HISTORIC AND DESIGN REVIEW COMMISSION

HDRC CASE NO: 2022-428
ADDRESS: 1614 E HOUSTON ST
LEGAL DESCRIPTION: NCB 577 BLK 16 LOT 5
ZONING: RM-4, H
CITY COUNCIL DIST.: 2
DISTRICT: Dignowity Hill Historic District
APPLICANT: William Brewer/Done Right Construction DBA
OWNER: GOFORTH DERETHA & PATRICIA SCOTT
TYPE OF WORK: New construction of a 1.5-story, single-family structure
APPLICATION RECEIVED: February 27, 2023
60-DAY REVIEW: Not applicable due to City Council Emergency Orders
CASE MANAGER: Claudia Espinosa

The applicant is requesting conceptual approval to construct a 1.5-story, single-family structure.

Exterior Elevation Front

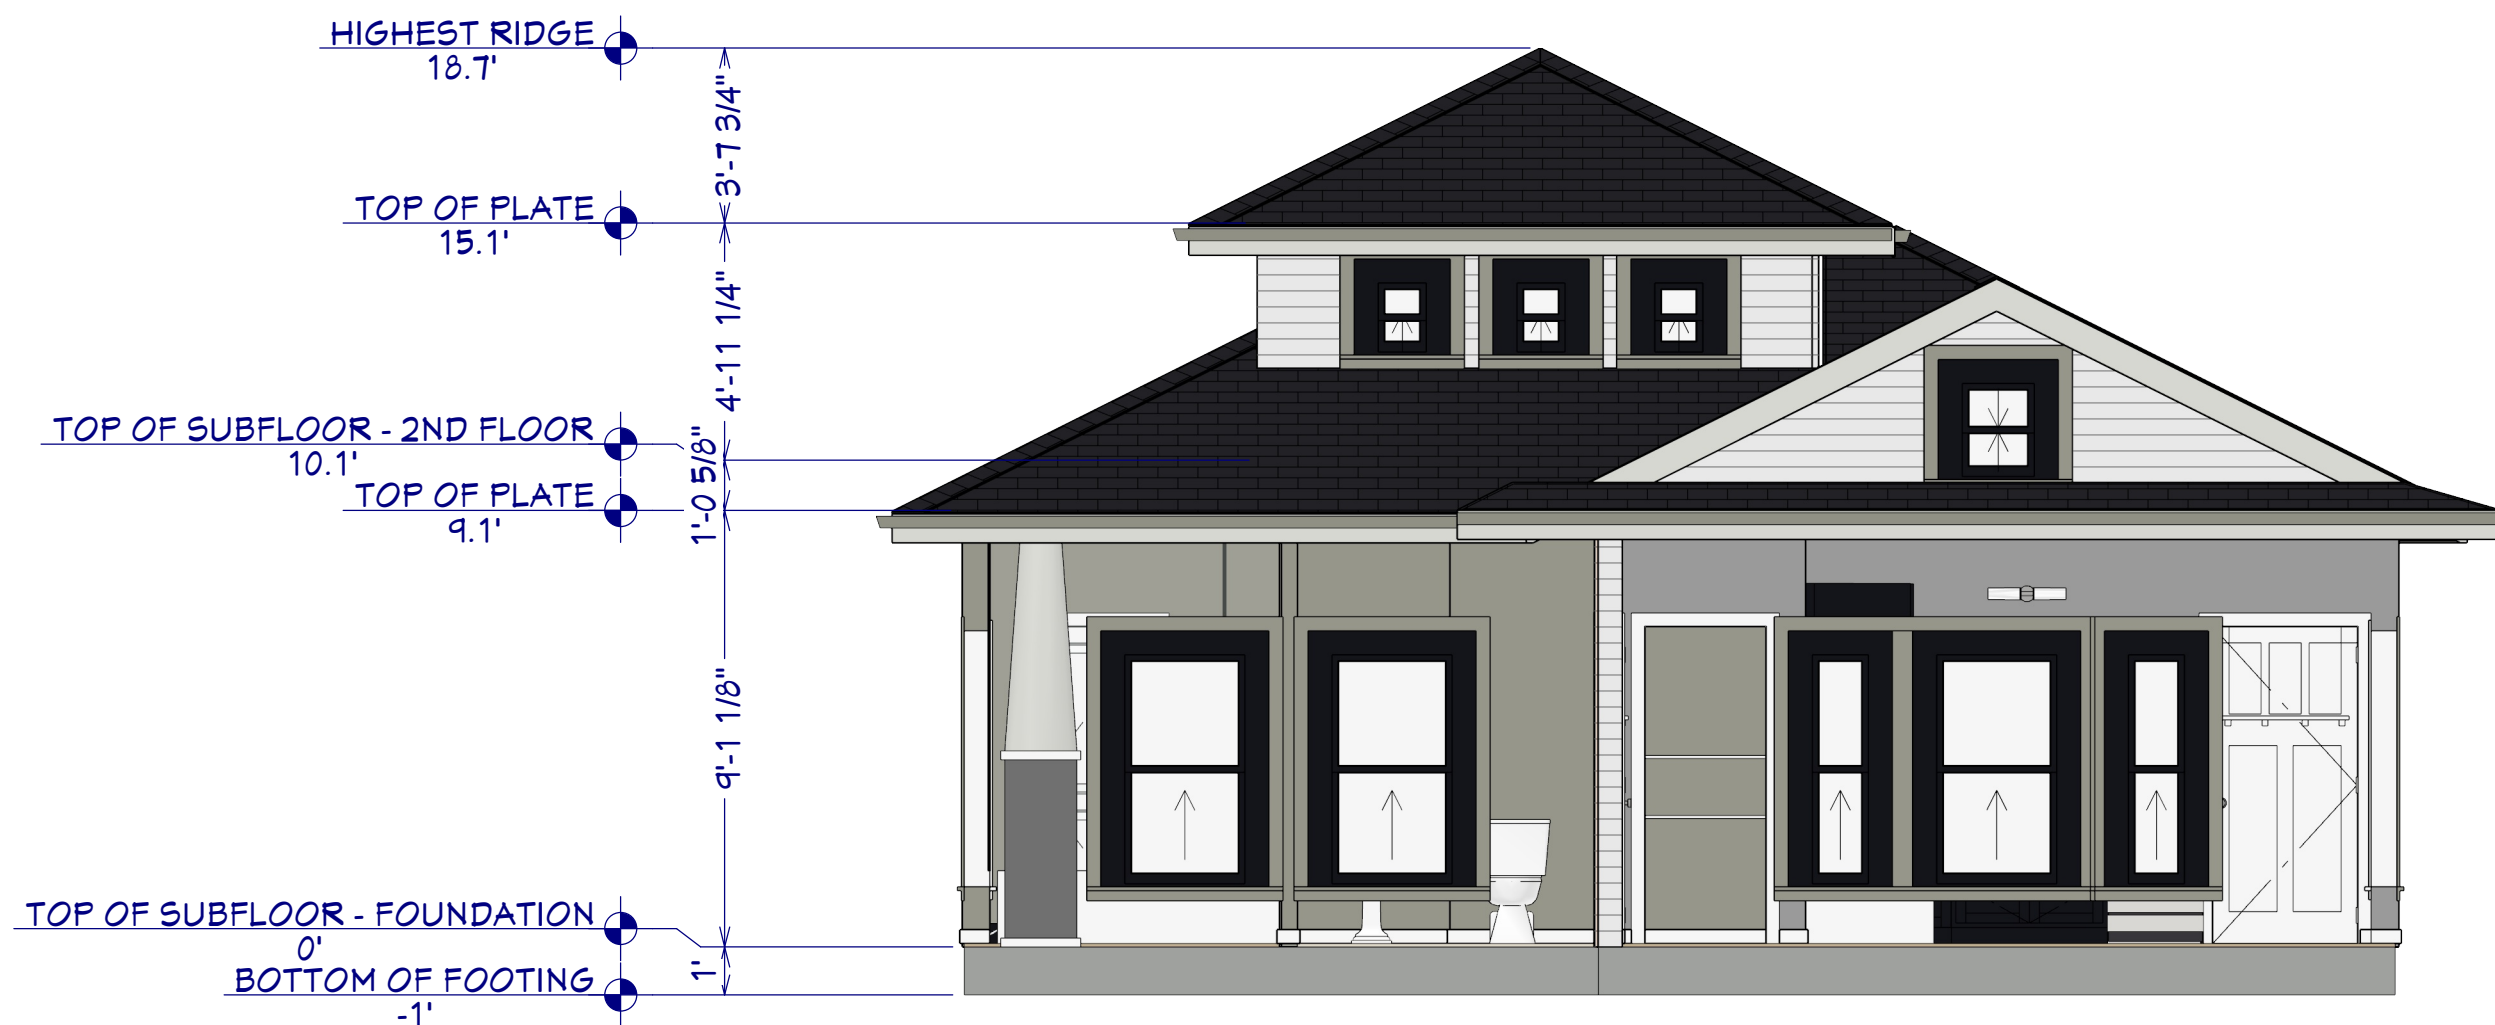
- g. **SCALE & MASS** – The applicant has proposed to construct an approximately 980-square-foot 1.5-story residential structure. According to Guideline 2.A.i for New Construction, new structures should feature a height and massing that is similar to historic structures in the vicinity. In residential districts, the height and scale of new construction should not exceed that of the majority of historic buildings by more than one story. This block within the Dignowity Hill Historic District features 1-story historic structures. Staff finds that the proposed scale and massing of the structure appears generally appropriate.

- i. **ROOF (FORM)** – The applicant has proposed a hipped roof form with a dormer for the proposed new construction. According to Guideline 2.B.i for New Construction, new construction should feature roof forms that are consistent with those predominantly found on the block. Staff finds this request is reflective of the Dignowity Hill Historic District and is consistent with the guidelines.

Exterior Elevations

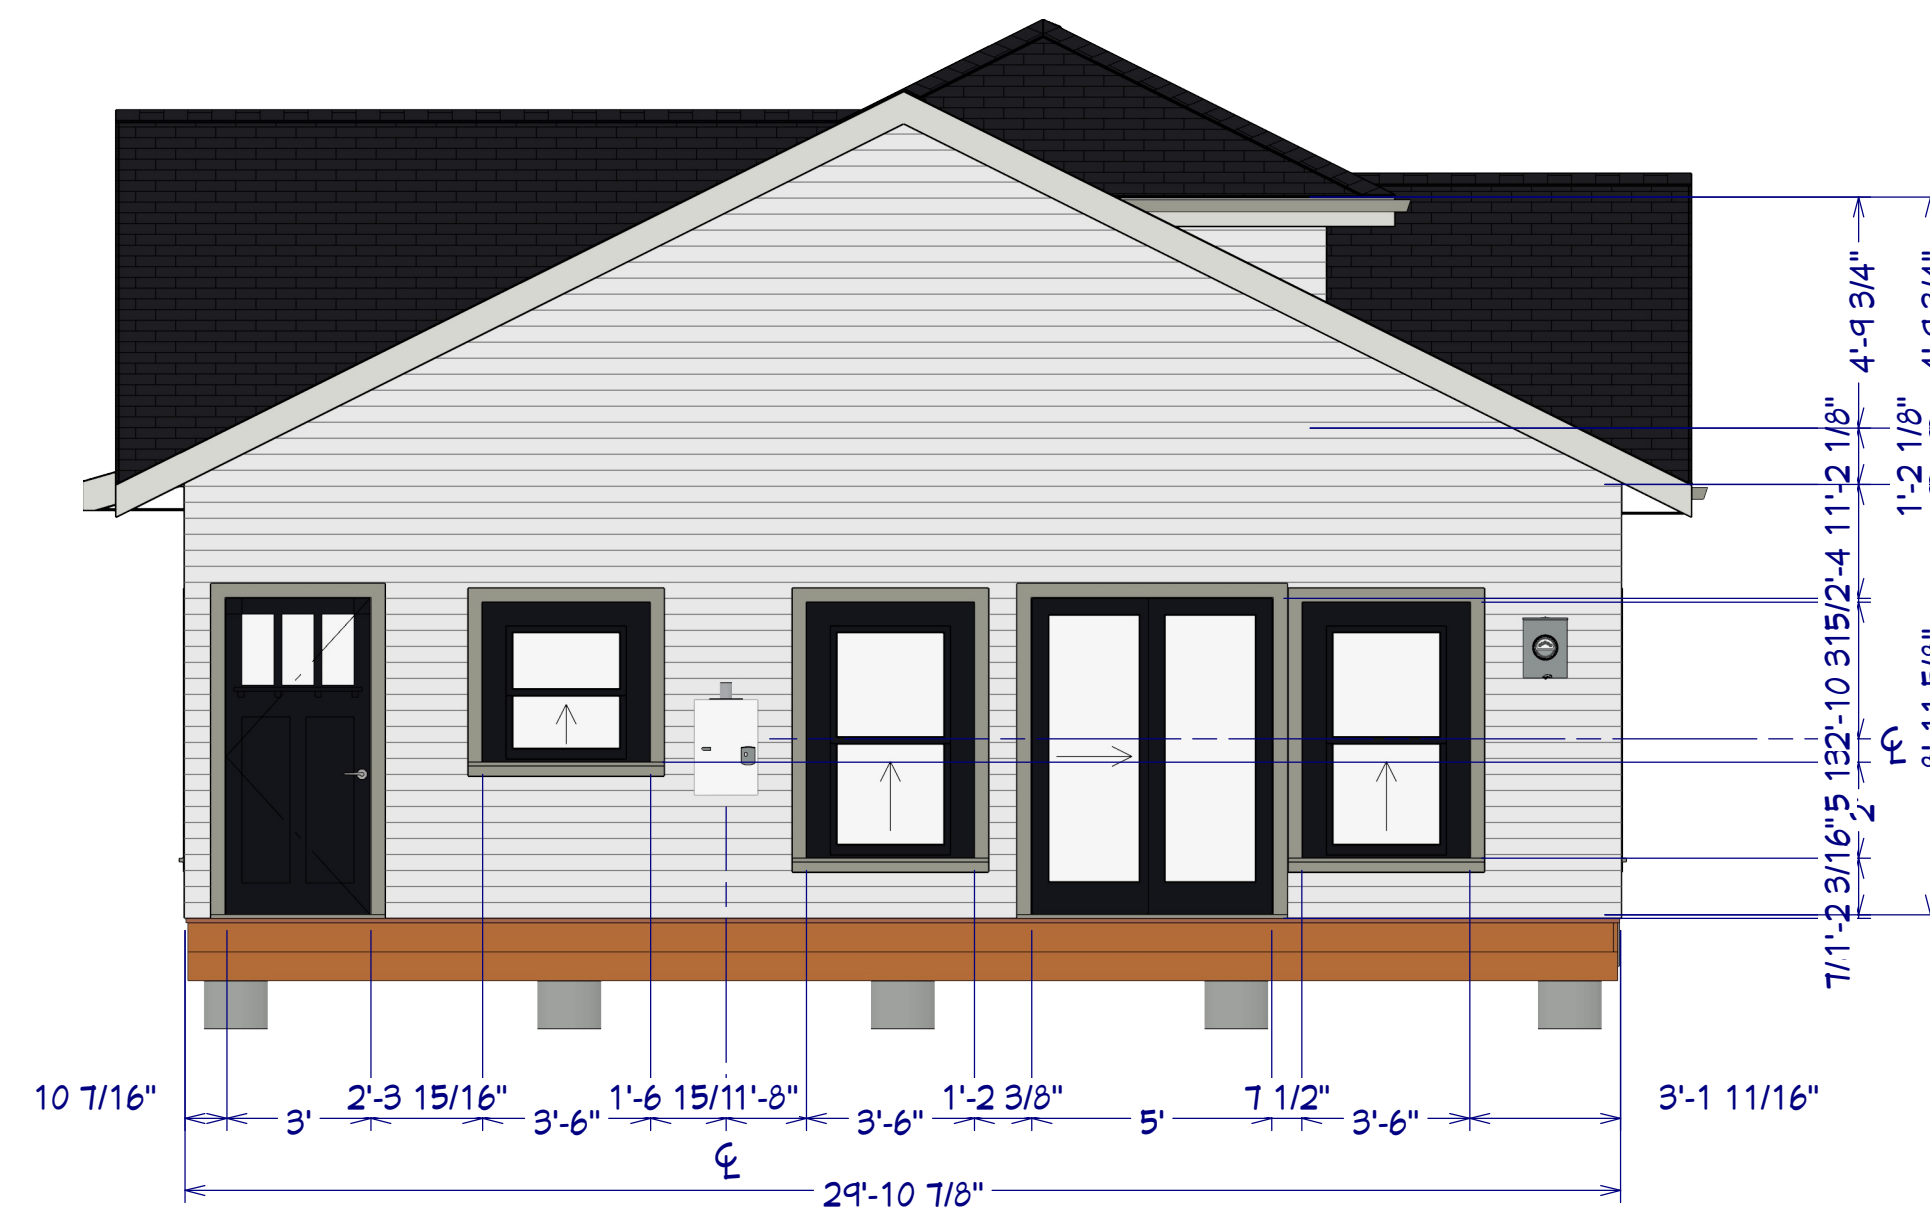
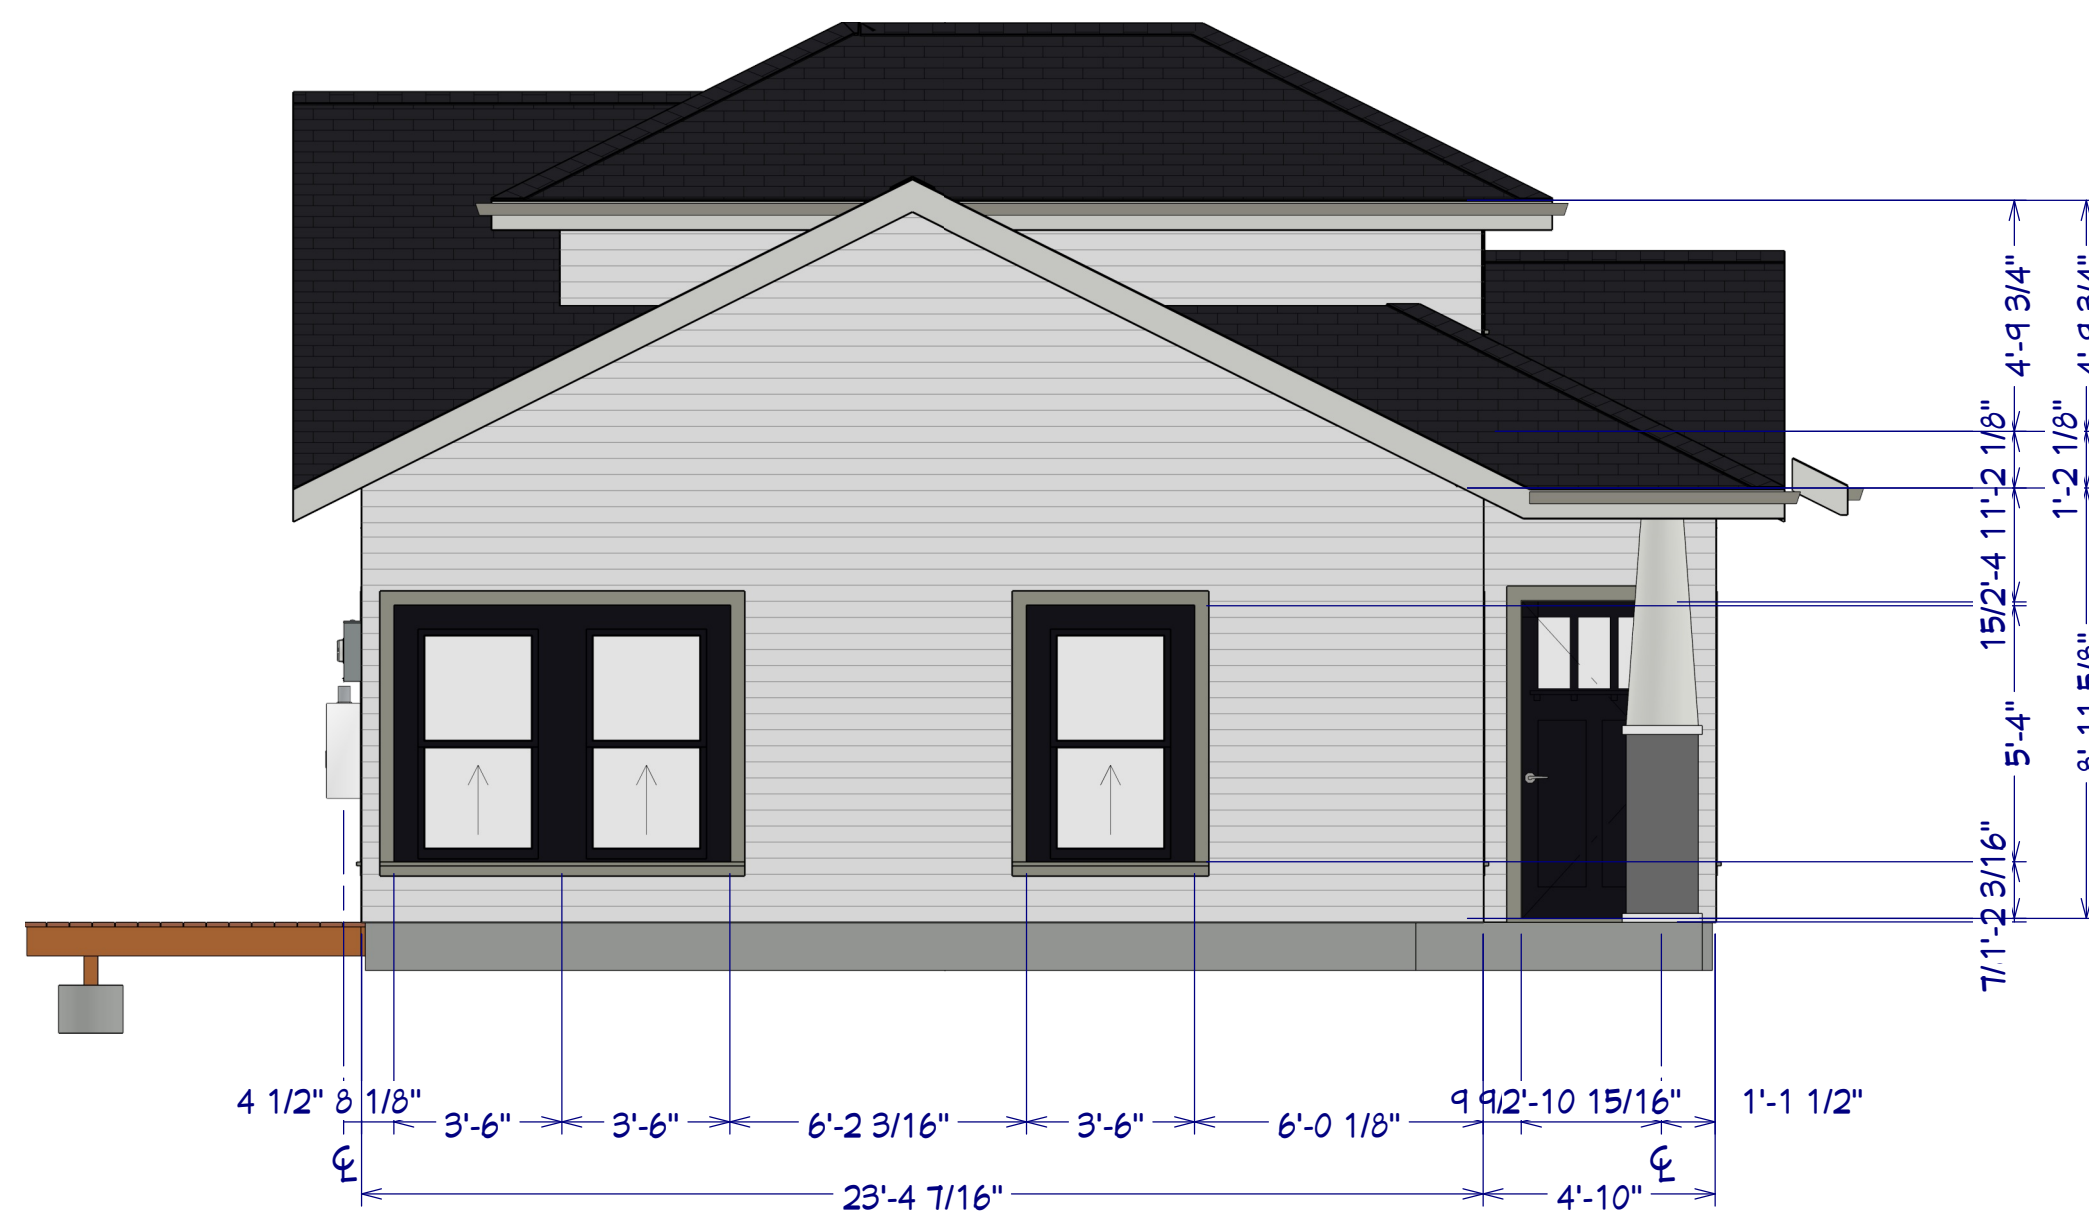
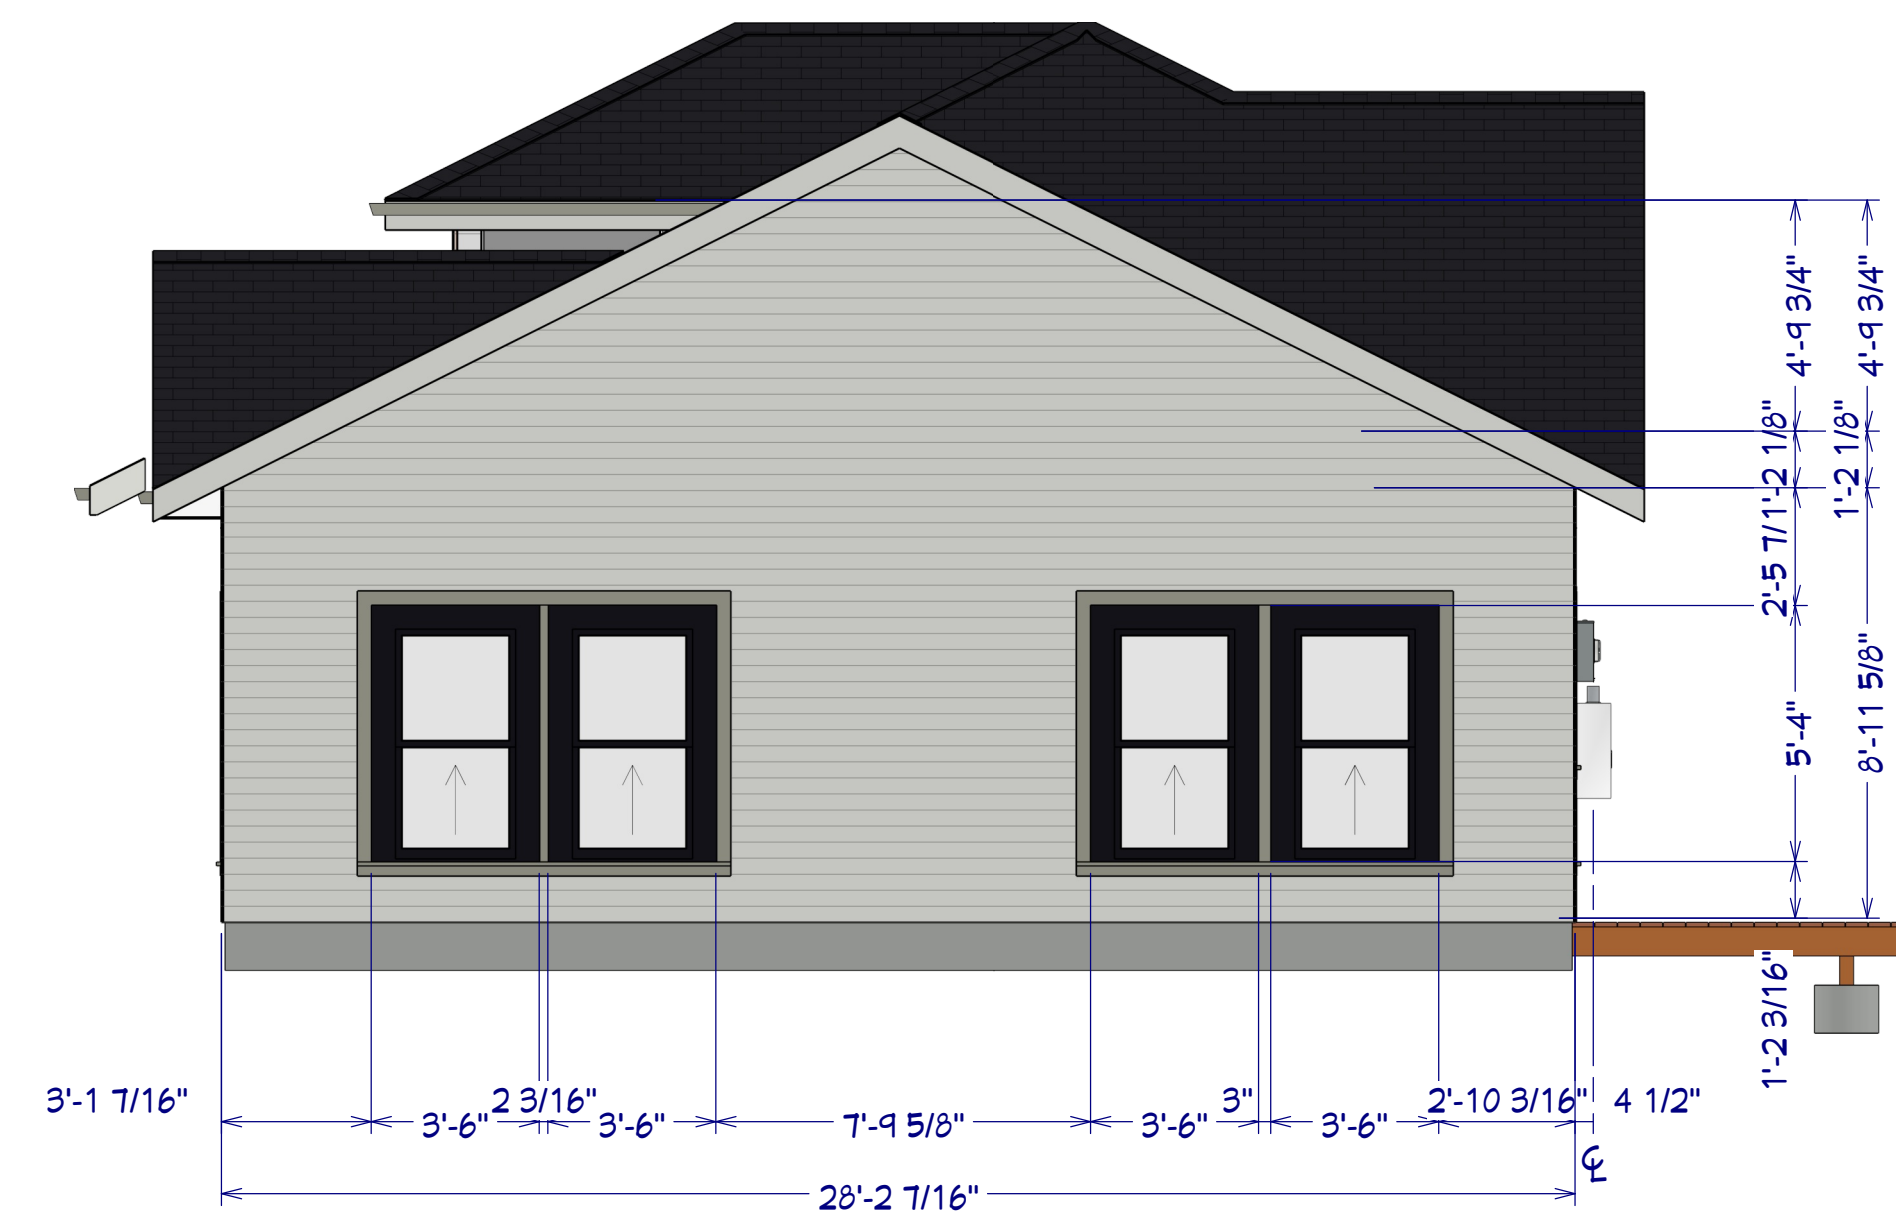
- e. **GENERAL DESIGN** – As stipulated at the time of demolition approval, the applicant must propose a front elevation that is a reconstruction of the original façade. The original house featured a low, cross gabled roof with inset front porch and side entry. The proposed design includes an inset porch at a similar location and a recreation of the original design as stipulated. The proposed roof form is compatible in comparison to the original structure. Staff further finds that a side-facing entry is appropriate and is consistent with the recreation of the front façade as stipulated by the HDRC Commission. The existing driveway, walkway and fencing will remain.

- h. **PORCH RECONSTRUCTION** – The original front porch form featured a side entryway, two sashed windows, and four wrought iron columns. Additionally, the front porch extends beyond the front façade projection and wraps beyond the front façade to the east. The applicant has proposed to reconstruct the porch to include the side entryway, two sashed windows and one porch column. Staff finds the proposed front porch to be inconsistent with reconstruction of the front porch as required by the HDRC. Staff finds that the installation of additional columns will more closely reflect the appearance of the existing front porch and that the footprint of the front porch should match the original layout and dimensions.

- m. RELATIONSHIP OF SOLIDS TO VOIDS – Guideline 2.C.i for New Construction stipulates that new construction should incorporate window and door openings with a similar proportion of wall to window space as typical with nearby historic facades. Windows, doors, porches, entryways, dormers, bays, and pediments shall be considered similar if they are no larger than 25% in size and vary no more than 10% in height to width ratio from adjacent historic facades. The applicant has proposed a fenestration pattern on the front façade that features a side entryway and double hung windows that are reflective of the original structure, staff finds this to be appropriate. The fenestration pattern on the remaining elevation consists of double-hung windows, a sliding door, and wooden doors. Staff finds that the applicants proposed fenestration to feature traditional proportions and window configurations commonly found in the district.

- ii. That the applicant updates the proposed elevations to feature a front porch that more closely matches the footprint, dimensions, and appearance of the existing front porch and submits the updated drawings to staff for review prior to returning to the HDRC based on finding h.
